DOVER PLANNING BOARD – AGENDA

Meeting Type: Regular Meeting
Meeting Location: Council Chambers – City Hall, 288 Central Avenue
Meeting Date: **Tuesday, April 26, 2016**
Meeting Time: **7:00 pm**

PLANNING BOARD - STAFF MEMO FILE #P16-05

**Re: Pointe Place Residential and Commercial Mixed Use Development
 Planning Board Approval Plans,
 City Proj No. P16-05
 Altus Project #4390**

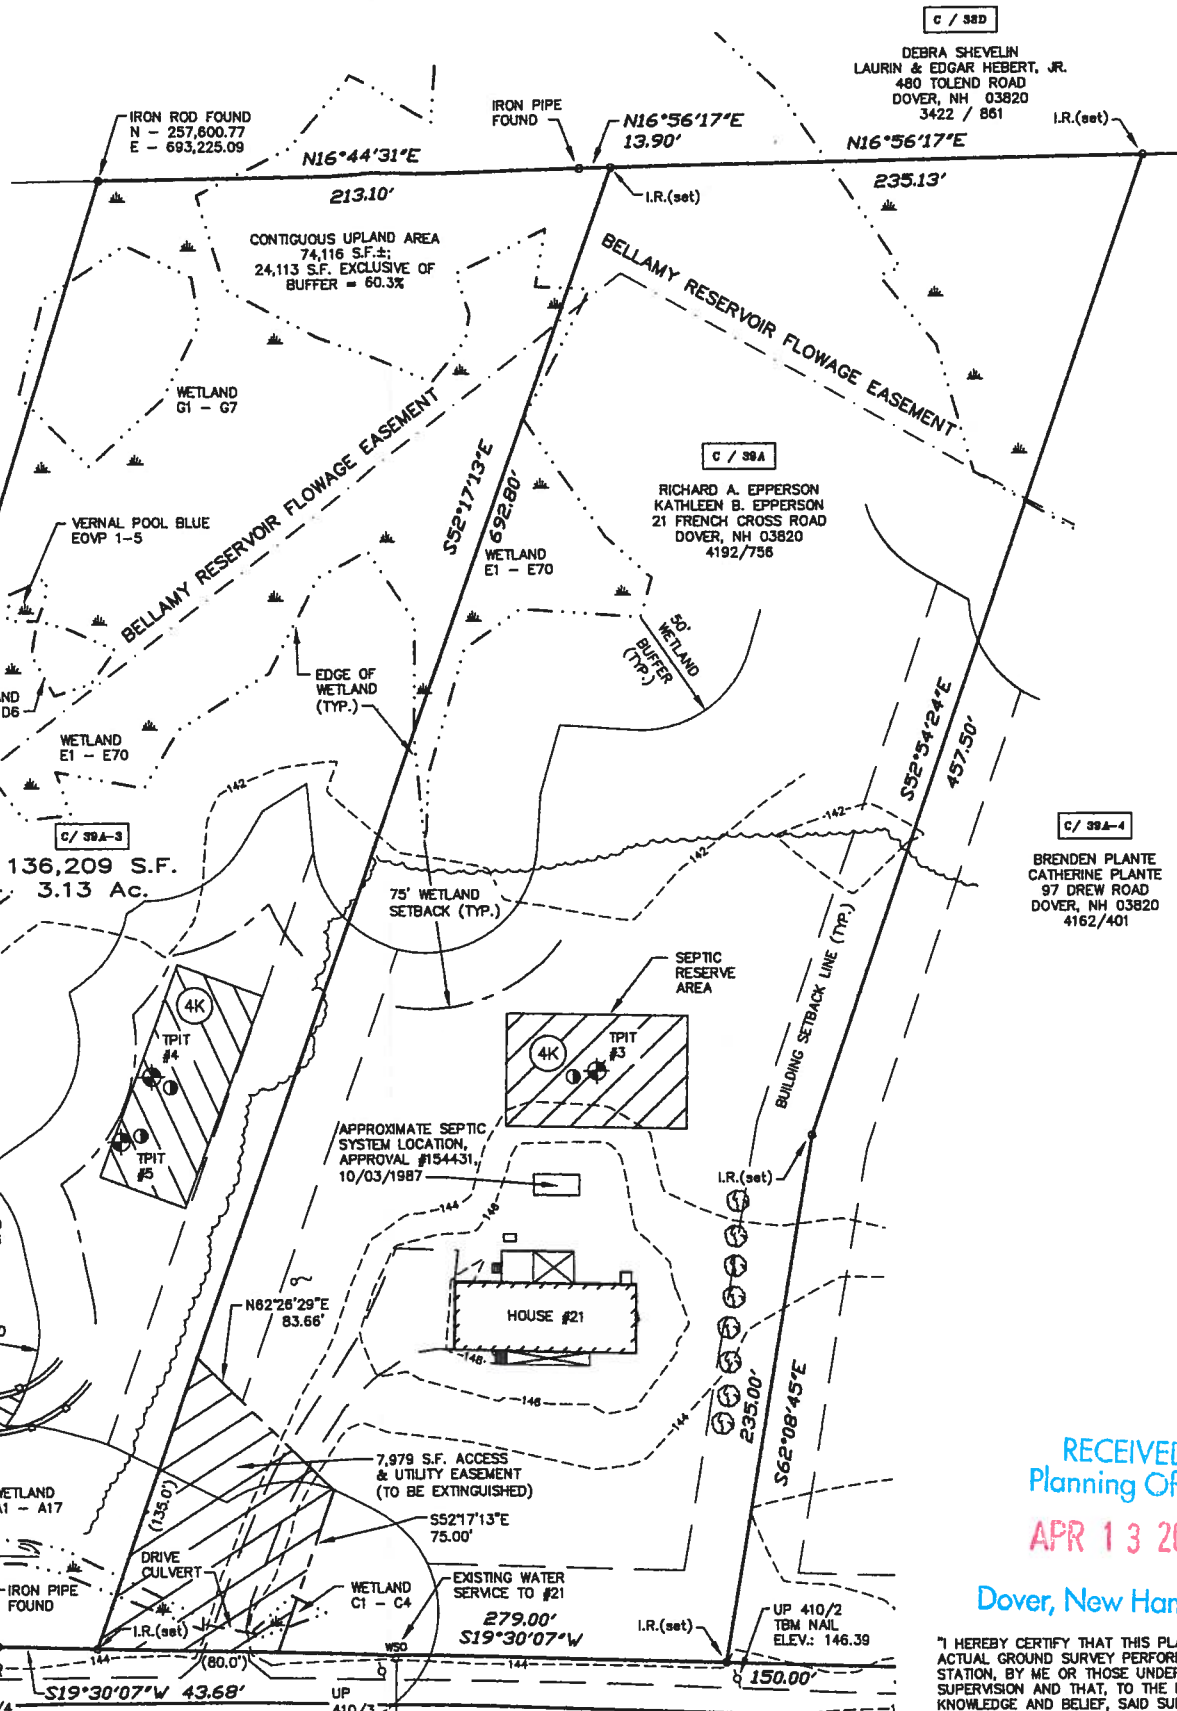
Pratt: I am a Planning Board alternate. I would like to see new technology or innovative design to reduce the impact of the driveway. I would want to reduce the impacts to biodiversity and ecosystems.

S-1

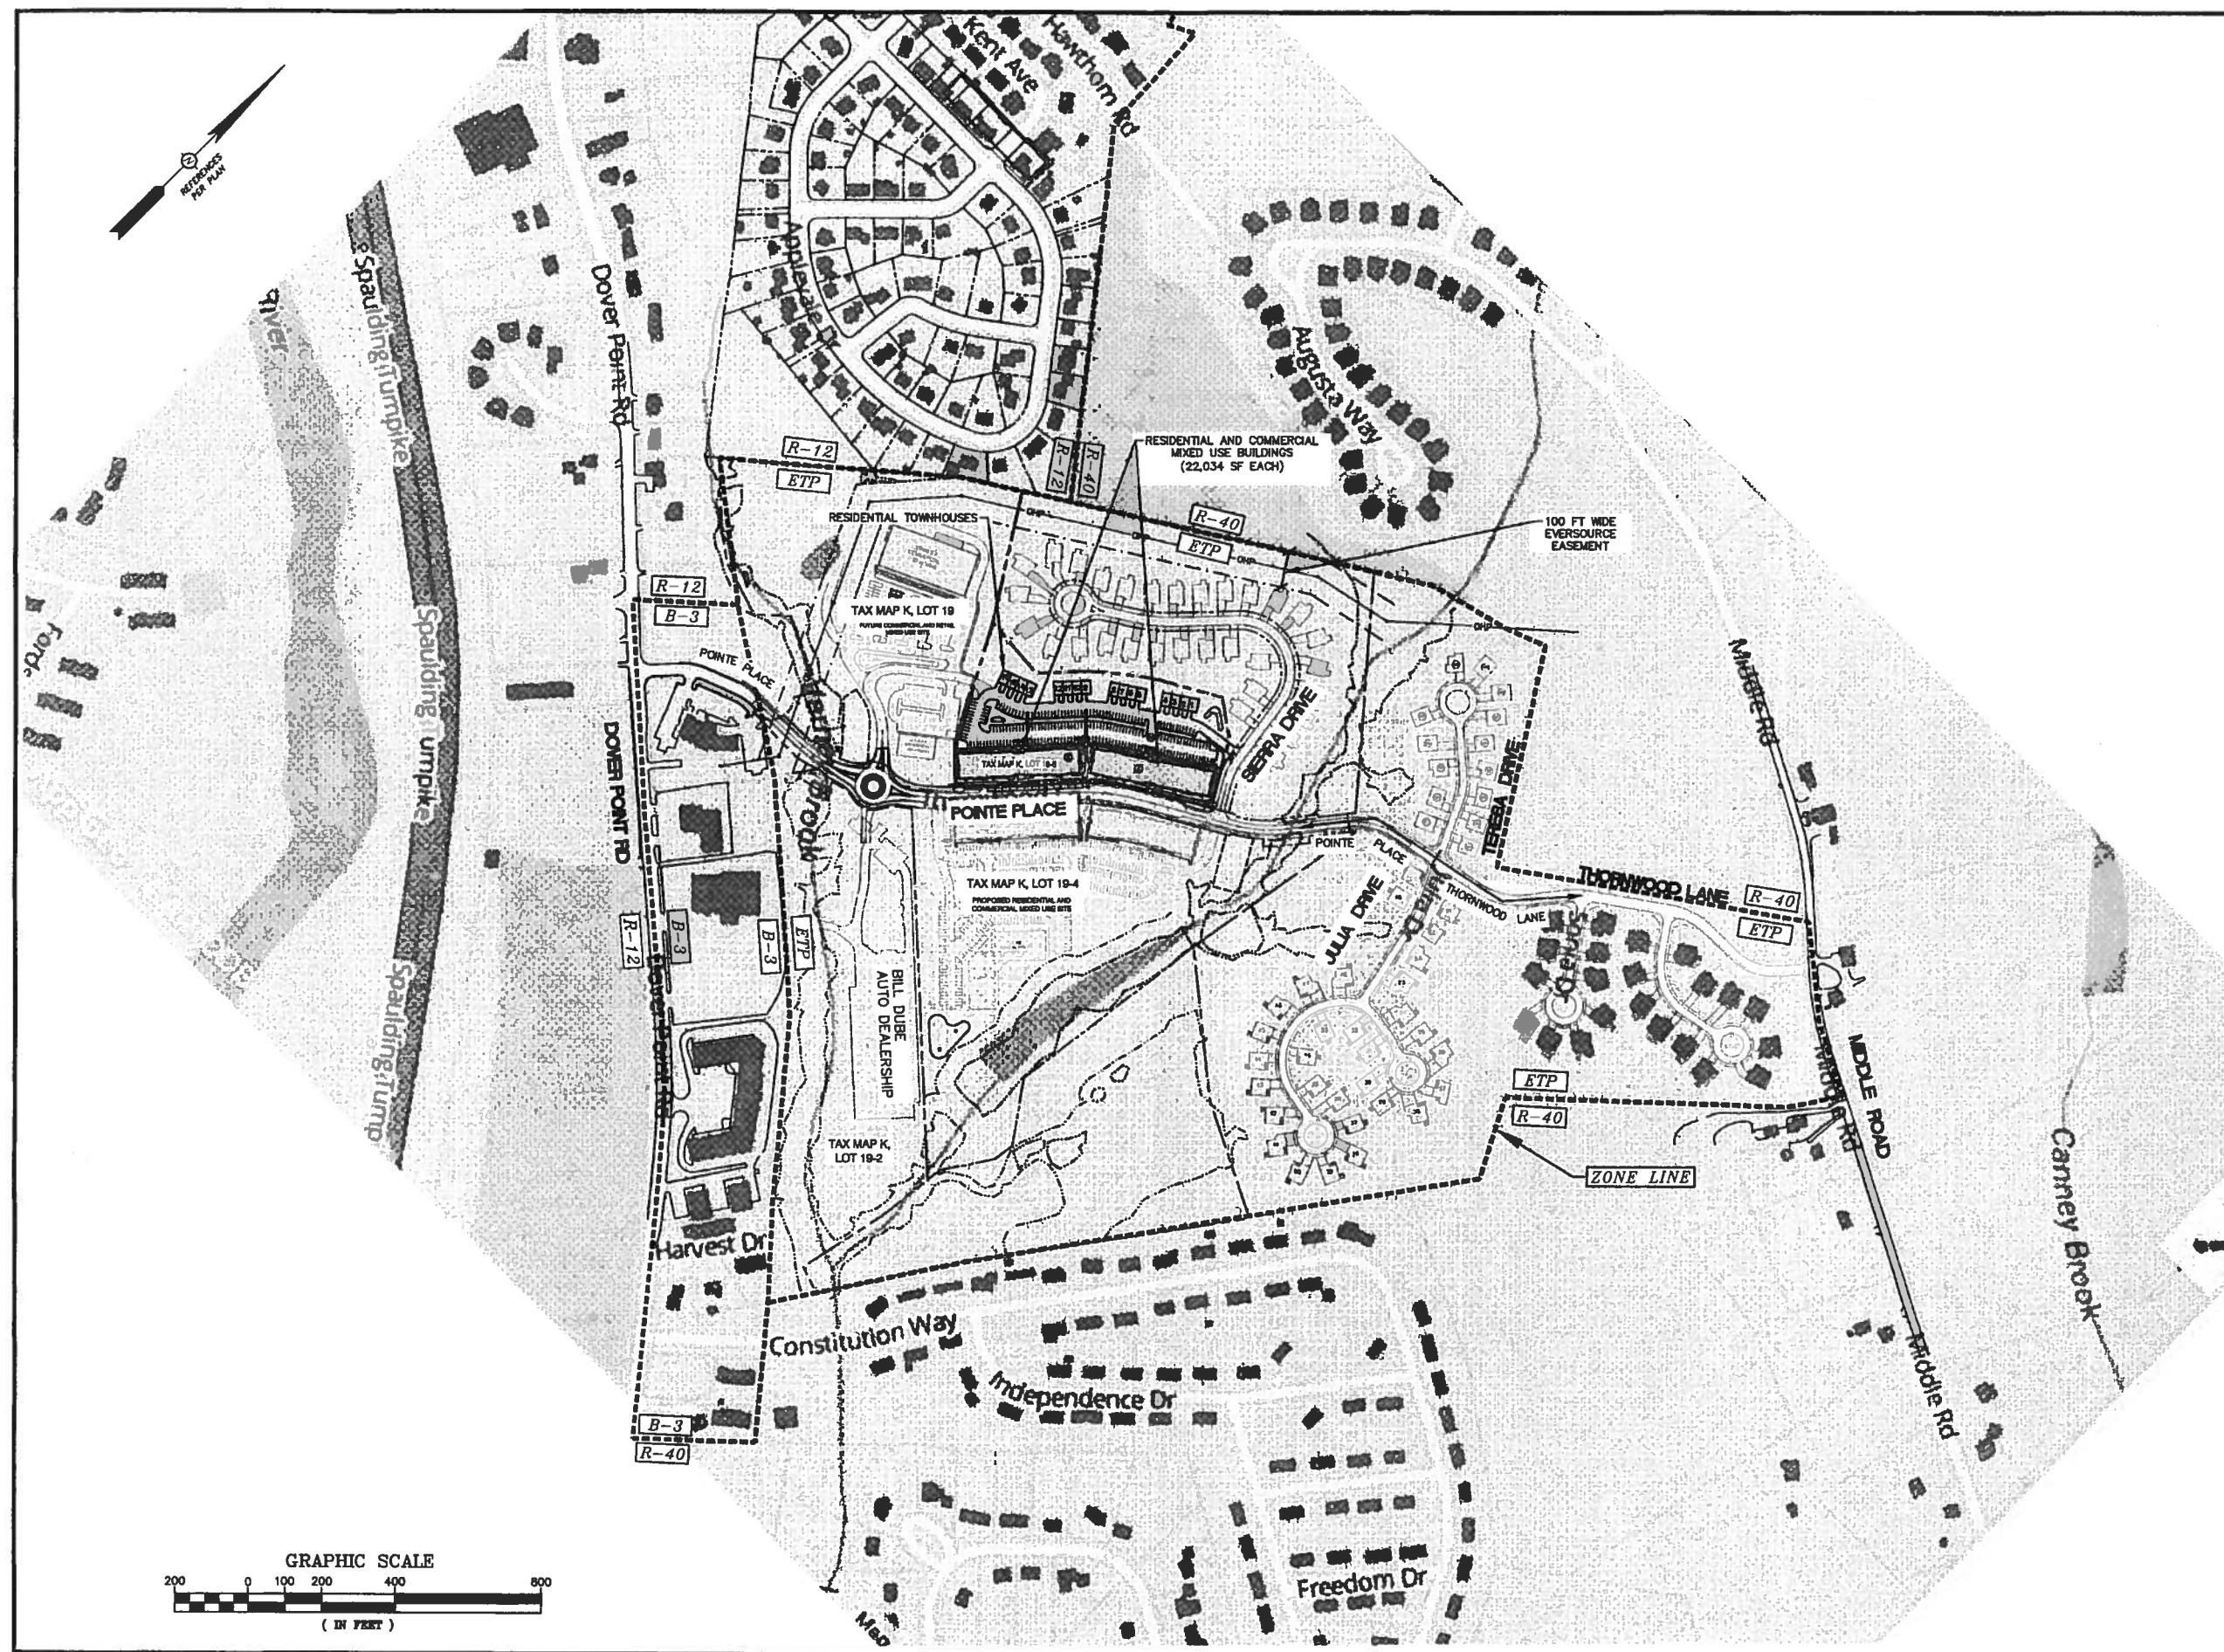
- On Sheet S-1:
 - Indicate number of units per building
 - Provide detail of existing earth berm shown
 - Clarify existing or proposed 30’ sewer easement

- On Sheet S-1:
